**MICROCHIP****PIC18F2420/2520/4420/4520****PIC18F2420/2520/4420/4520 Rev. A1 Silicon Errata Sheet**

The PIC18F2420/2520/4420/4520 Rev. A1 parts you have received conform functionally to the Device Data Sheet (DS39631D), except for the anomalies described below. Any Data Sheet Clarification issues related to the PIC18F2420/2520/4420/4520 will be reported in a separate Data Sheet errata. Please check the Microchip web site for any existing issues.

The following silicon errata apply only to PIC18F2420/2520/4420/4520 devices with these Device/Revision IDs:

FIGURE 1: SCK PULSE VARIATION USING TIMER2/2

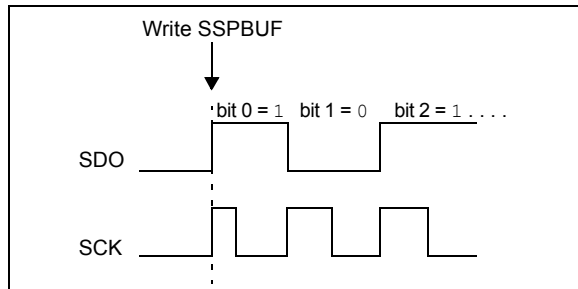
When the SPI is using Timer2/2 as the clock source, a shorter than expected SCK pulse may occur on the first bit of the transmitted/received data (Figure 1).

To avoid producing the short pulse, turn off Timer2 and clear the TMR2 register, load the SSPBUF with the data to transmit and then turn Timer2 back on. Refer to Example 4 for sample code.
